Woodbrook Phase 1

Quality Audit

Woodbrook Development Phase 1

Stage 1 Road Safety Audit

Figure 2-1 – Shared path crossing carriageway

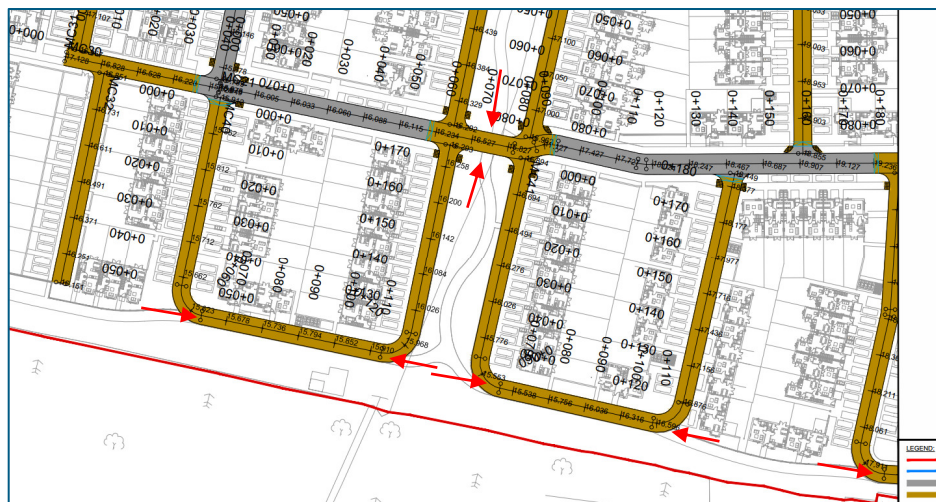
Drawing/Location: 5154251/HTR/DR/0102: Roads MC40, MC41 and MC21

5154251/HTR/DR/0105: Road MC42

The shared use path that bounds the development merges crosses the carriageway at various locations. VRUs and traffic may not expect to abruptly cross each other's path; this may lead to conflict.

The Designer should set out priority control measures at the locations described, affording advantage to VRU's where possible.

2.3	Y	N	The shared use path crossing the roads on raised tables. This will be a low speed environment and appropriate for the provision of uncontrolled crossings.	Y

Figure 2-2 – Shared path abuts carriageway

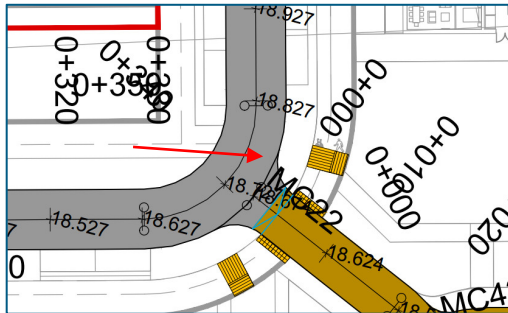
Drawing/Location: 5154251/HTR/DR/0104: Cycle-track & footpath west of MC43

The cycle track and footpath for (east bound movement) guides VRUs directly towards the carriageway without crossing provision. This may lead to conflict.

The Designer should consider providing crossing facilities at this location.

2.4	Y	Y		
2.5	Y	N	As this location is a shared space street with low vehicle speeds formal crossings are minimised to encourage informal crossing within the street.	Y

Figure 2-3 – Converging VRUs

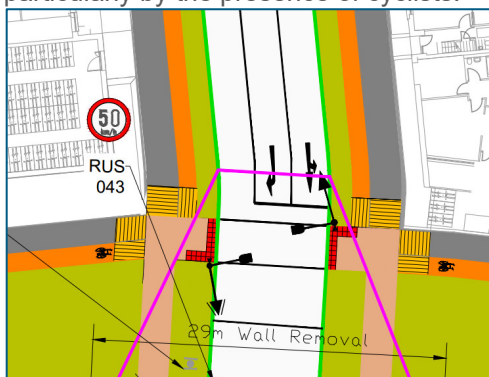
Location: 5154251/HTR/DR/0119: Ped Crossing to East of Traffic Signal

2 Cycle tracks and a shared use area converge in proximity either side of the toucan crossing. There is a risk of conflict where 4 opposing streams of VRUs converge particularly by the presence of cyclists.

The Designer should consider setting back the tramlines from the toucan crossing thereby increasing the distance between the converging VRUs.

2.6	Y	Y		
2.7	Y	Y		
2.8	Y	Y		
2.9	Y	Y		
2.10	Y	Y	As an interim measure the inline Bus Stop will be	Y
